**Response to NRC
Comments
on
*Assessment Report for
Well 1319 Area***

**Cimarron Corporation's Former
Nuclear Fuel Fabrication Facility
Crescent, Oklahoma**

**License Number: SNM-928
Docket Number: 70-0925**

Re: Docket No. 70-925; License No. SNM-928
Response to NRC Comments on Assessment Report for Well 1319 Area

ATTACHMENT 1
1319 ON-SITE TRENDS

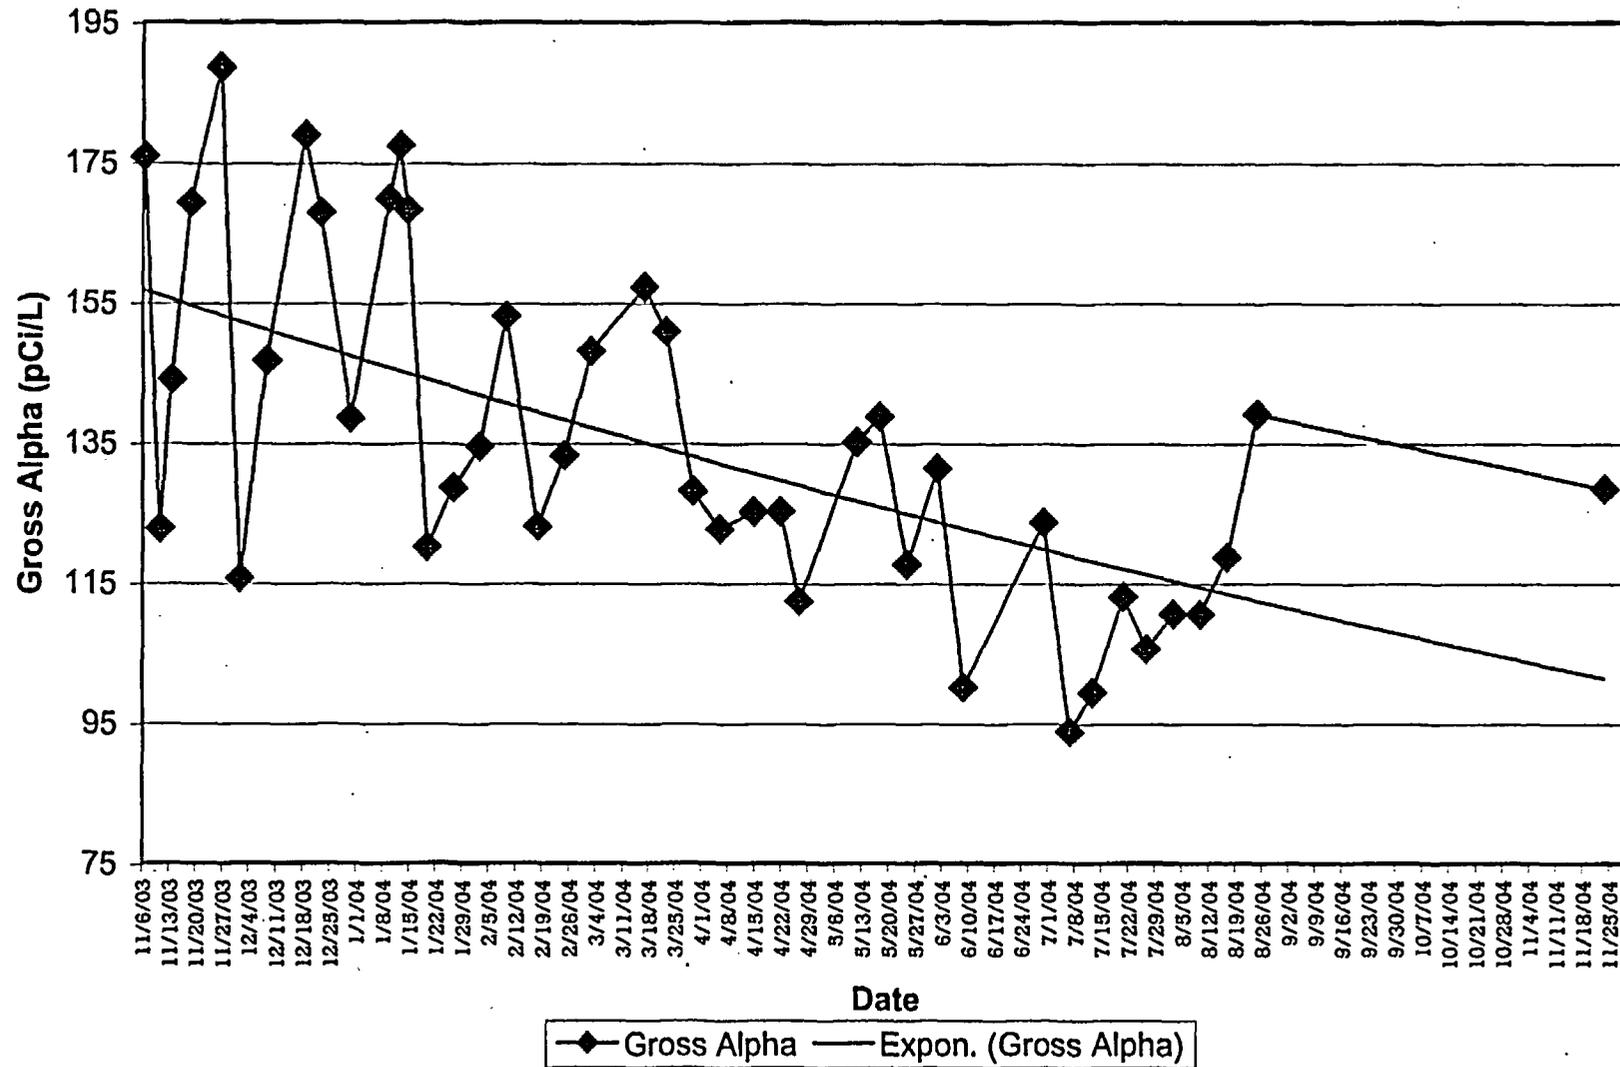
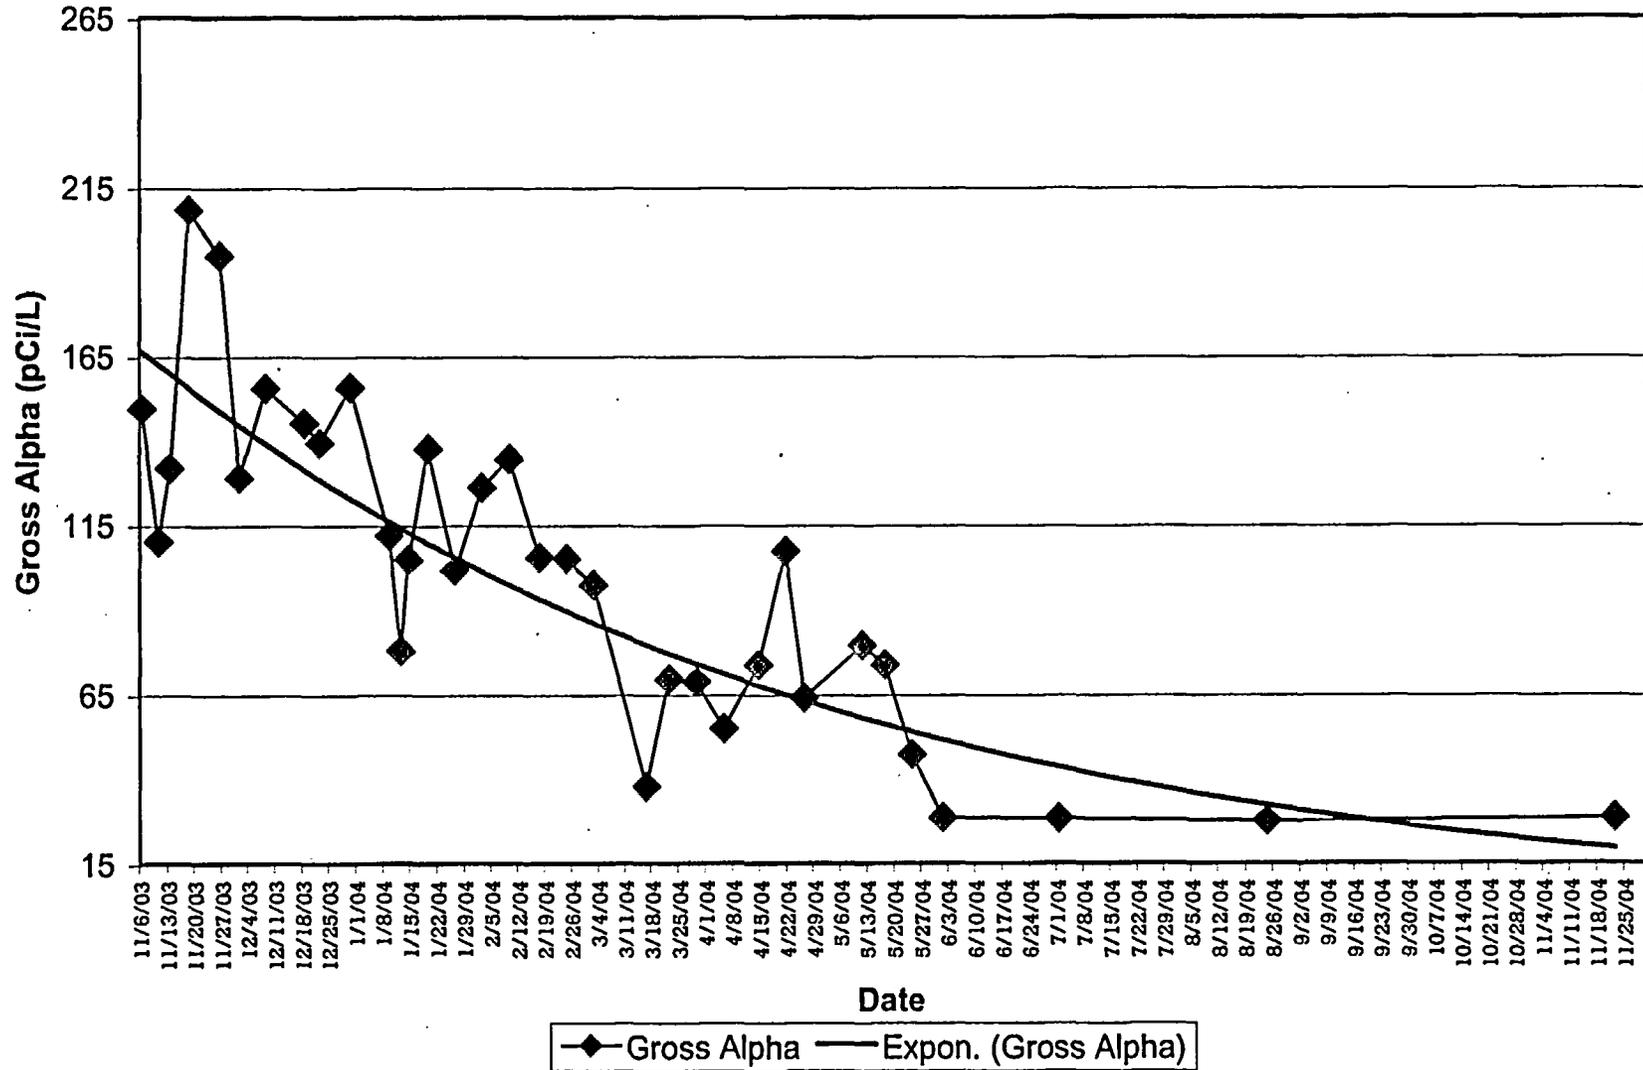
The licensee should discuss the history of groundwater pumpage (dates and time periods), approximate volume of groundwater pumped, and water levels before and after pumping for wells 1319, 1319B-1, and 1319C-1.

The licensee should discuss its plans for lowering the total uranium groundwater concentrations below the 180 pCi/L criteria in Sandstones B and C in this area. In this discussion, the licensee should consider its responses to comments 1 and 2 above and the figure entitled, “1319 On-Site Gross Alpha Trends”, in Appendix B it is recommended that sampling all or most of the 11 wells in the Well 1319 Area be conducted during the November 2004 sampling event.

Well 1319 was installed during the facility's operating years to provide a water supply for the plant. However, the well was never used; consequently, there is no history of pumping from this well. Cimarron installed air tubing and discharge piping in wells 1319B-1 and 1319C-1 in November 2003. These wells were pumped relatively continuously by air purging from November 2003 to July 2004. Freezing temperatures during winter and air compressor breakdown caused periodic temporary shutdown of the pumping effort. In addition, pumping was intentionally discontinued for a brief time period (one to two weeks) for quarterly sampling events. This enabled sampling personnel to measure depth to groundwater, since water level indicators cannot be extended down the 2" diameter wells with the tubing installed. Pumping was terminated for Well 1319C-1 in June 2004. Pumping was terminated for Well 1319B-1 in August 2004.

Attachment 1 to this response includes a table and a graph entitled, "1319 On-Site Trends". This table lists the on-site gross alpha results for samples collected from these wells, and shows that over 420,000 gallons of water were pumped from Well 1319B-1, and over 425,000 gallons of water were pumped from Well 1319C-1 since pumping began in November 2003. Attachment 2 includes a table showing all gross alpha and total uranium results obtained from our off-site analytical

Cimarron has already reduced total uranium concentrations in Sandstones B and C below the license criteria, as demonstrated by both gross alpha and total uranium concentrations in Wells 1319B-1 and 1319C-1. This data is provided in Attachment 1. Groundwater decommissioning is complete, and it is appropriate to transition from an environmental monitoring program to a post-decommissioning monitoring program for this area.
